Application by RWE Renewables UK Solar and Storage Limited for an Order Granting Development Consent for the Byers Gill Solar Project. PINS Reference No: EN010139.

Deadline 8 Responses and Comments

Subject **Installation and operation of a Solar Farm together with all associated works, equipment and necessary infrastructure by Lightsource BP**
Response to Letter received from Goodenough Ring Solicitors – 9 July 2024

Appendix 1 - Figure 1

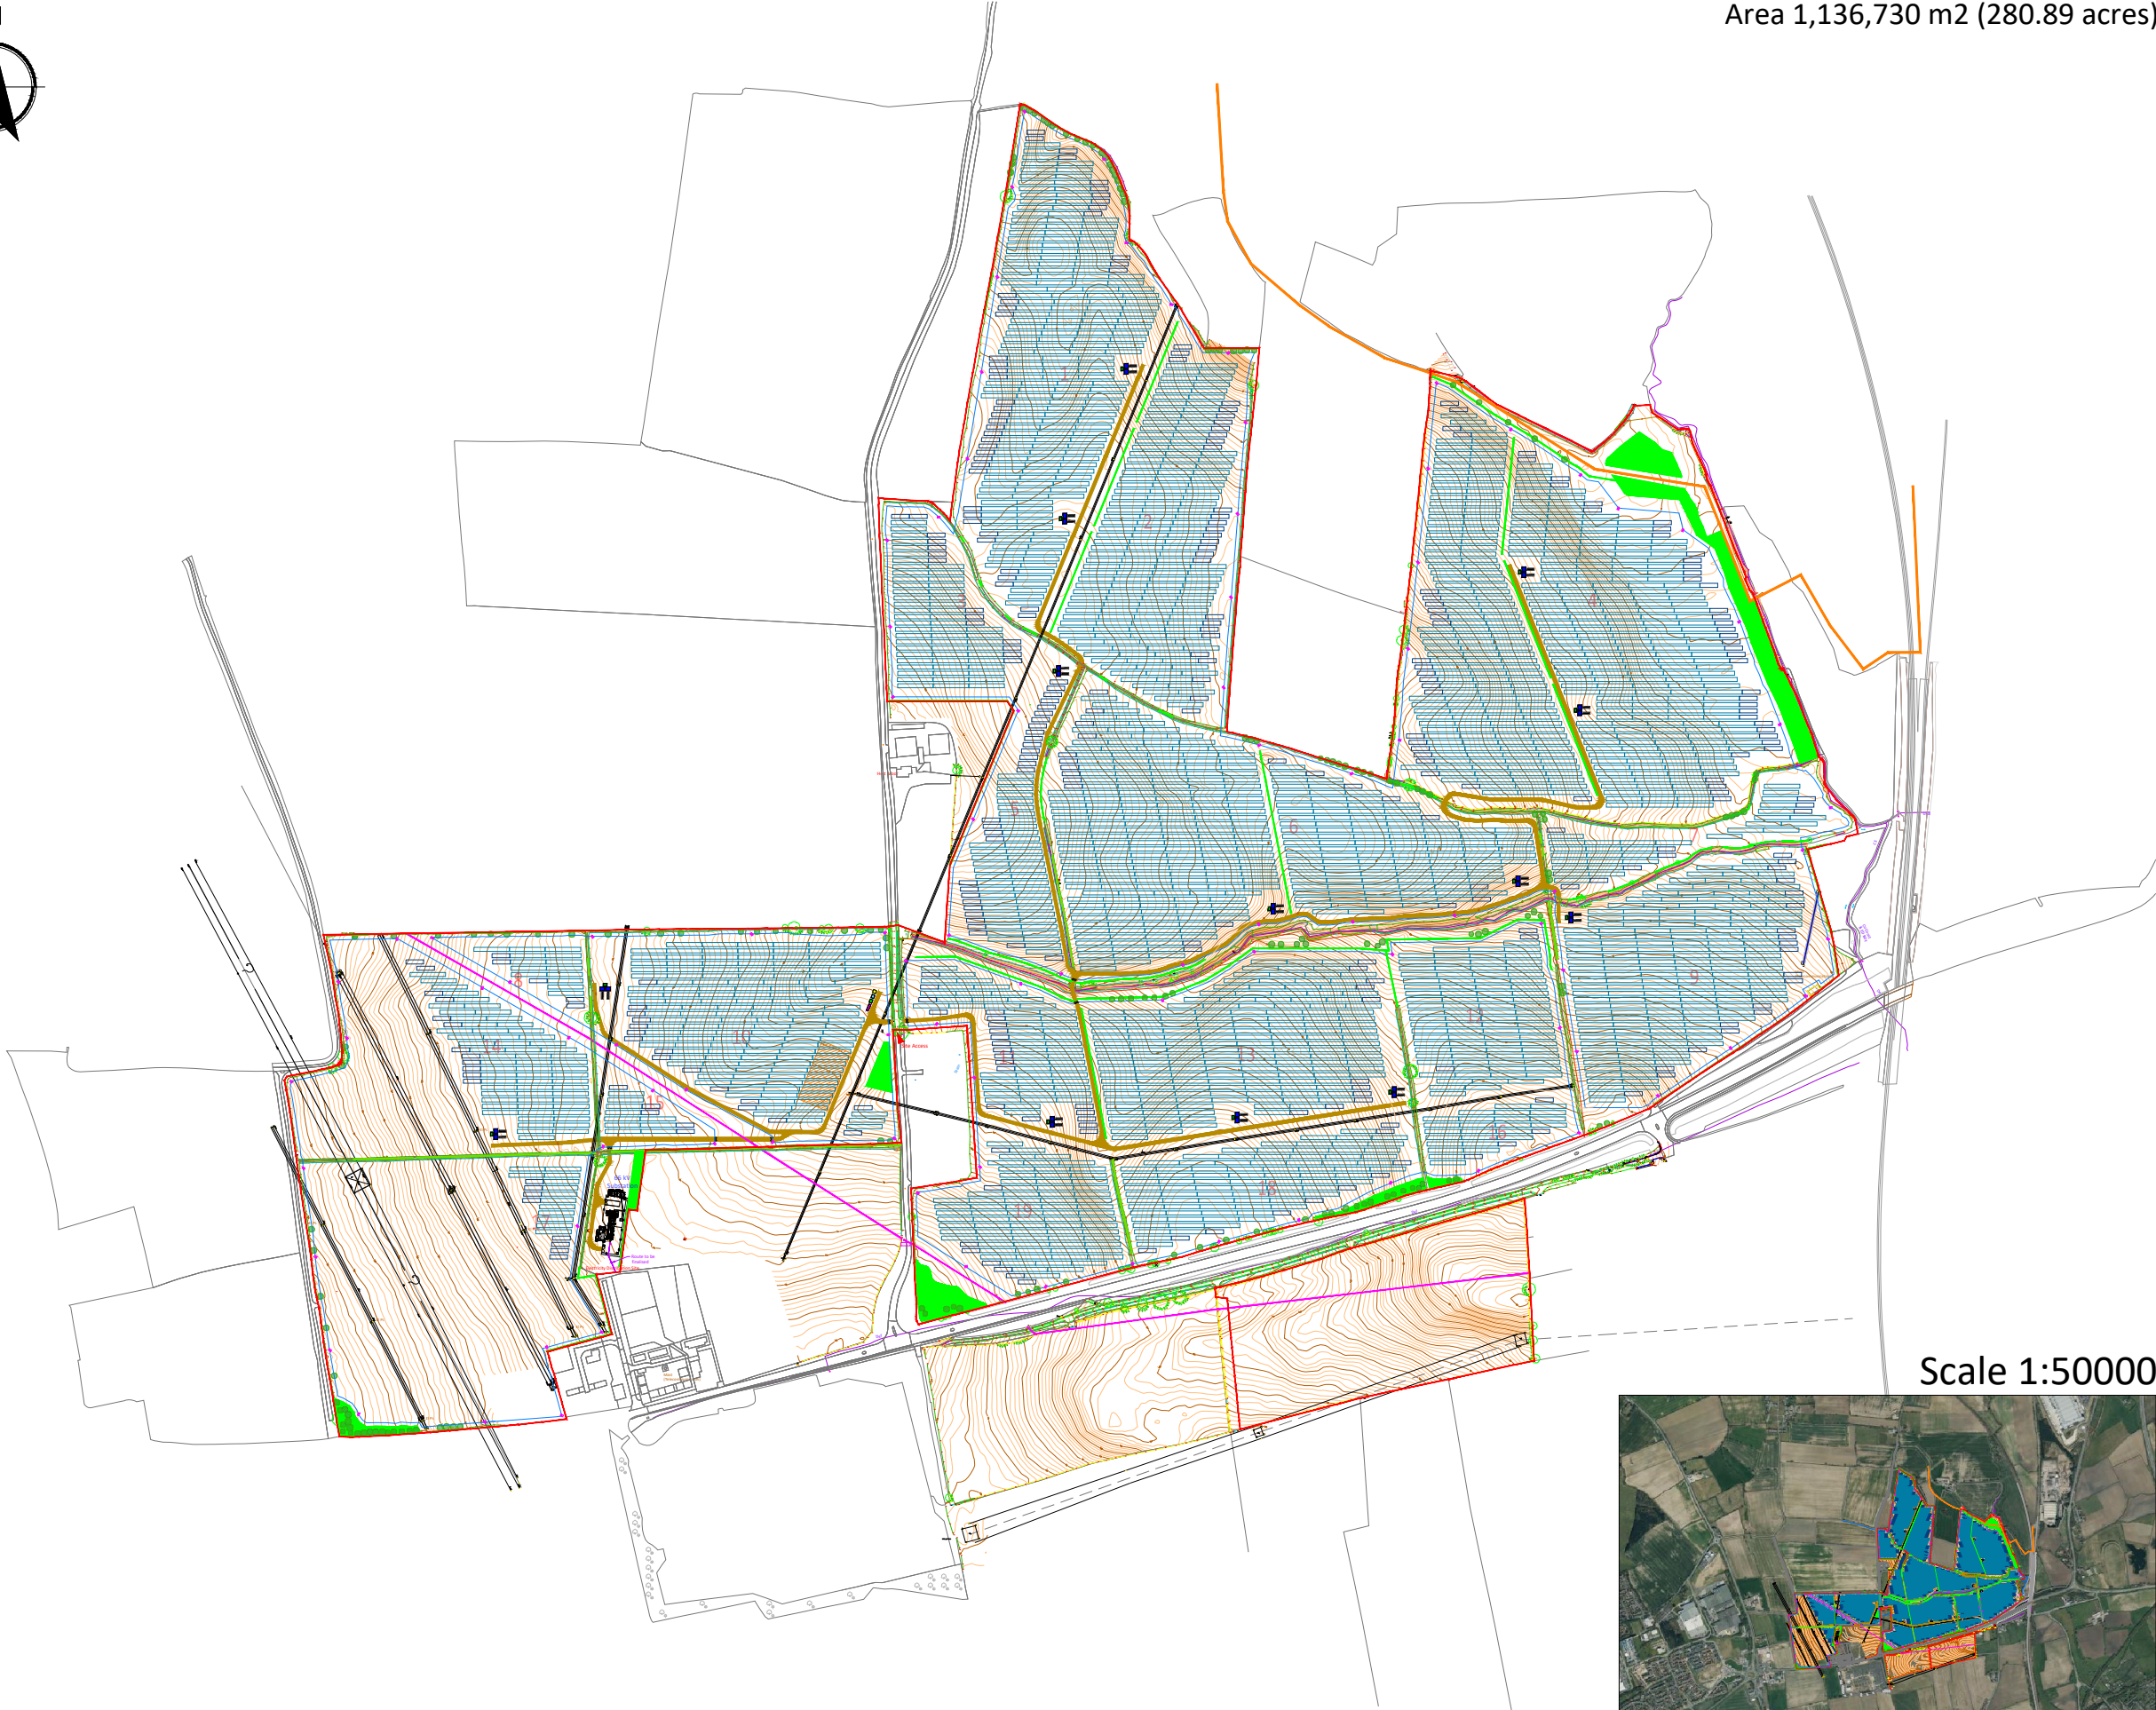
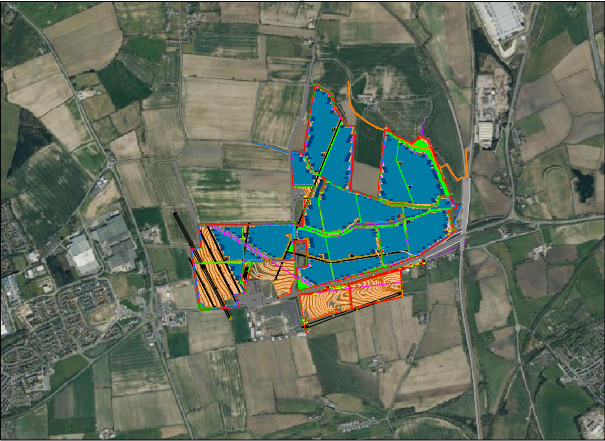
#	Letter	LSbp technical responses
		<p>design and materials (i.e. the panel specification) to be approved at a later stage when the condition is discharged.</p> <p>Overplanting could be provided using different panel types and capacities, and an illustrative scenario is provided below in Item 6.</p>
6	If the Council or the applicant wish to defend the 77 MW figure, then they should demonstrate exactly how it has been calculated.	<p>The applicant's statement of 8th March 2024 referred to the scheme having a MW (DC) or MWp level of ~ 77MWp. This is an approximate estimate at this stage of an 'optimised design' for a 49.9MWac project for this site. 77MWp provides an overplanting ratio of approximately 1.54 on a scheme that is capped through planning condition (Condition 19) to export no more than 49.9MW (AC). 77MWp is based on the assumption there are 135,420 panels and that a 570Wp panel is installed (which is reasonable to assume at this stage, as set out in Item 3). The typical elevation in the planning application is sized such that it could accommodate the dimensions of panels of various ratings and various manufacturers' specifications.</p> <p>If 135,420 x 570Wp rated solar panels were used for Hett Moor Solar Farm it would result in an installed DC capacity of around 77MWp. The solar panels could be installed without extending either the height of the table submitted in the typical elevation or the number of panels in the layout plan. There may however be some very minor difference in the lengths of the panels. Final layout plans and elevations would need be in accordance with the approved plans and elevations (Condition no. 4) unless otherwise approved through Condition No. 10.</p> <p>Figure 1 is the layout plan from the original application with 135,420 panels of a typical panel. This is the plan for which planning permission is sought.</p> <p>Alternatively, a second illustrative alternative layout is provided in Figure 2 (Opt 2) which illustrates what an optimised layout could look like for a ~77MWp solar farm with 685Wp panels. This design arranges the tables with slightly wider spacing between each row and thereby optimises the design for an installed DC capacity of around 77MWp.</p> <p>This would be beneficial to the operation of the Hett Moor Solar Farm as the increased row spacing would reduce potential shading and, in turn, increase the performance of the panels throughout the days, and over the year particularly at times when the sun is lower in the sky. As can be seen by the overlay, in this scenario, the full extent of the site</p>

#	Letter	LSbp technical responses																								
		<p>would be required as per the original planning application with only a few tables not required (as illustrated in red).</p> <p>A summary is provided in the table below:</p>

<table><tr> <th></th><th>Original layout (Figure 1)</th><th>Scenario 2 (Figure 2)</th></tr><tr> <td>No. Solar Panels</td><td>135,420</td><td>112,380</td></tr><tr> <td>Assumed Panel Type and Capacity (Wp)</td><td>570</td><td>685</td></tr><tr> <td>Total installed DC capacity (MWp)</td><td>77.19</td><td>76.98</td></tr><tr> <td>Maximum installed inverter capacity (MWac)</td><td>49.9</td><td>49.9</td></tr><tr> <td>Overplanting ratio</td><td>1.54</td><td>1.54</td></tr><tr> <td>Shading loss</td><td>5%</td><td>3.3%</td></tr><tr> <td>Estimated specific yield (kWh/kWp)</td><td>879</td><td>936</td></tr></table>
